# ENVIRONMENTAL REVIEW TEAM REPORT

## SEYMOUR HIGH SCHOOL ATHLETIC COMPLEX and CHATFIELD PARK IMPROVEMENTS SEYMOUR, CONNECTICUT

FEBRUARY 1981

# FIGURE 2. SIMPLIFIED SITE PLAN\*

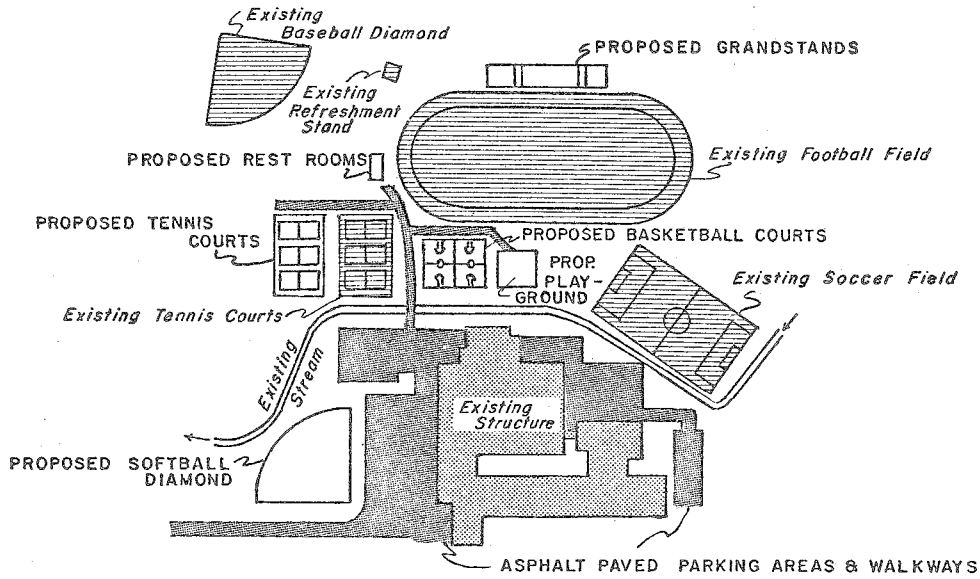
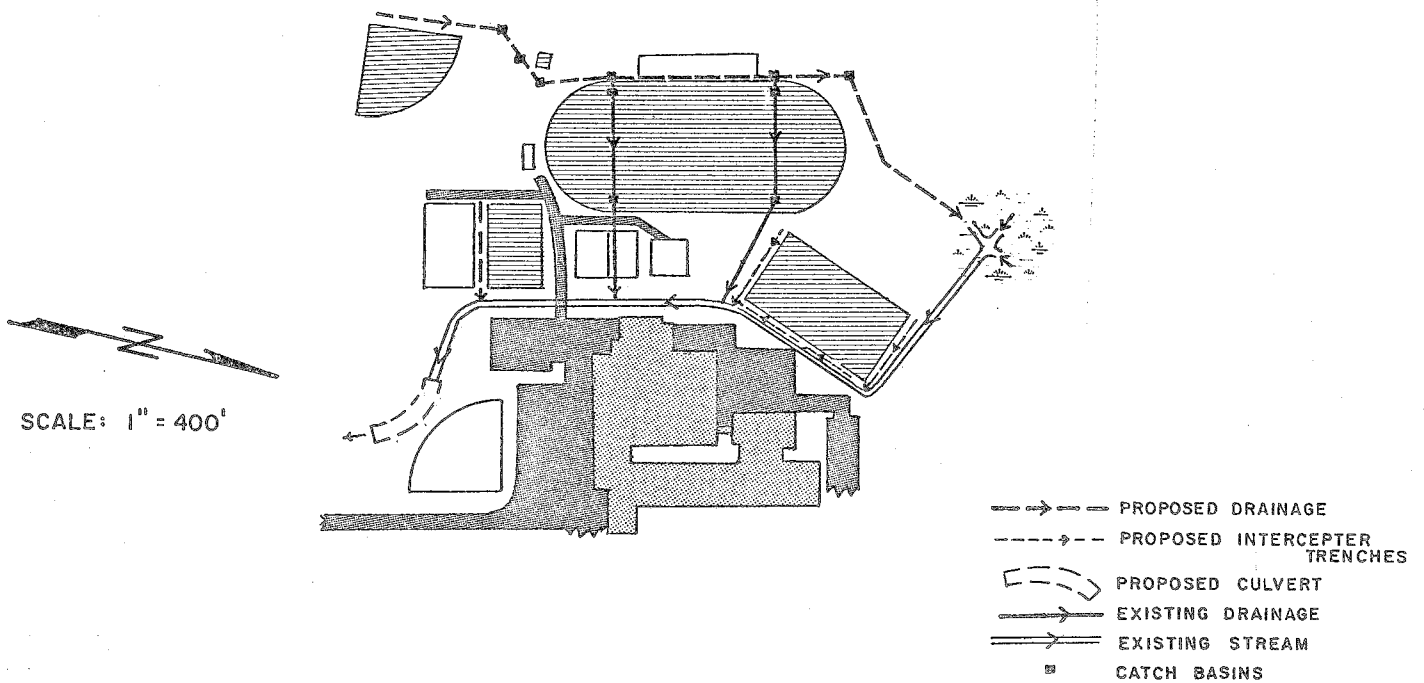
As shown by the soils map, the Seymour High School site is underlain by this soil type to the north and south of the existing football field. These soil areas will receive additional stormwater run-off under the proposed plan via the drainage improvements. In addition, it appears that the proposed tennis courts may encroach on this wetland area to the south.

The proposed drainage channels would be generally effective only during wet periods, when the compact till-artificial fill soils are unable to absorb surface moisture. During those times, surface runoff would be partly diverted from the playing fields. The longest new channel, which would run along the western sides of the existing baseball diamond and track, would transmit water into a pond-wetland in the northcentral section of the site. The pond-wetland would serve as a temporary storage area for the water, mitigating whatever minor flow rate increases might otherwise occur. Runoff volume may be increased by a very slight amount from the additional paved surface area (basketball and tennis courts and playground), but the amount would be negligible in relation

With construction of the proposed tennis courts in the southern portion of the property, care should be taken to carefully analyze the soils in this area. Available mapping indicates that this area could be partially underlain by wetland soils. If so, very careful engineering will be required to overcome the natural limitation of the soil.

It is important however that a sound engineering plan and erosion and sediment control plan be developed and implemented both during the construction phase and after construction is completed. Also a sound maintenance plan should be developed and followed. This plan should include annual application of nutrients (lime and fertilizer).

FIGURE 2.  
SIMPLIFIED SITE PLAN

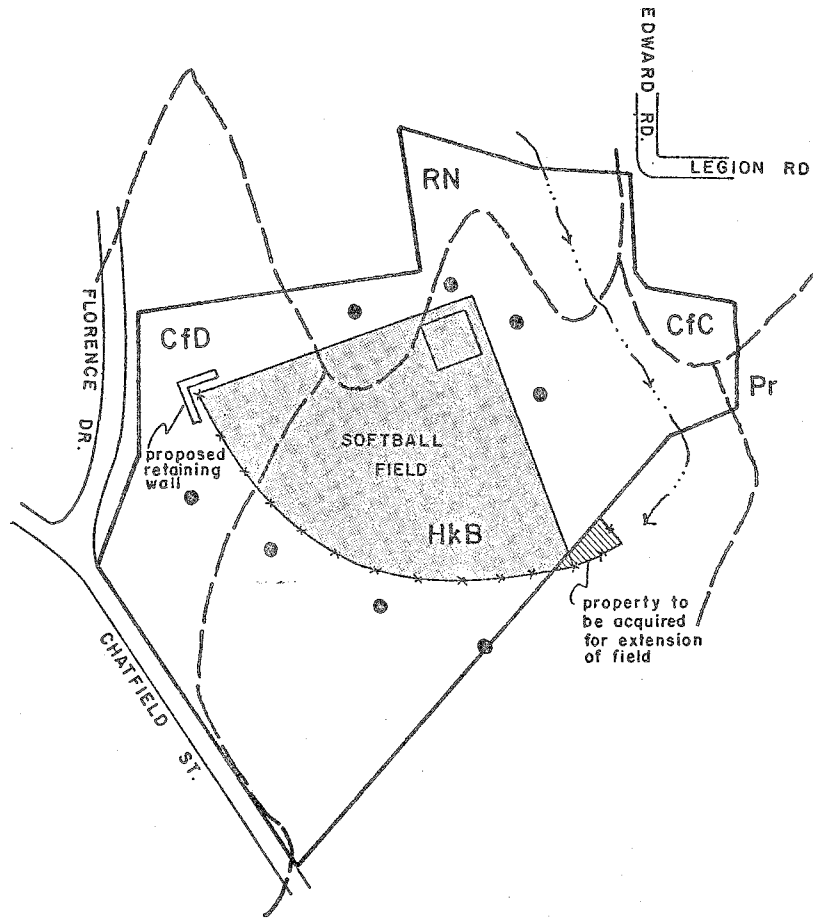
Figure 2 of this report shows the soil types on the Chatfield Park property as mapped by the USDA Soil Conservation Service. The three soils affected by this proposal are briefly described below. It should be recognized that the soils on much of the site have been altered by the cutting and filling done to construct the softball field.

Lighting of the Park will generate more activity and usage and thus will increase noise levels in the area. Littering can also be expected to increase. Littering can be controlled through the provision of trash receptacles and regular park maintenance. If noise levels become a problem to neighboring residents, use of the Park can be restricted during the evening hours by imposing a conservative curfew on the lighting. With installation of lights, efforts should be made to minimize the glare into surrounding houses.

Although a small parking lot for 6-8 cars is present at Chatfield Park, on-street parking at Chatfield Street has been the main source of parking space. With increased use of the site, it may be desirable to install additional parking space. There is room for such a facility on the western edge of the property off Chatfield Street. A gravel parking lot is recommended for this area to avoid run-off problems.
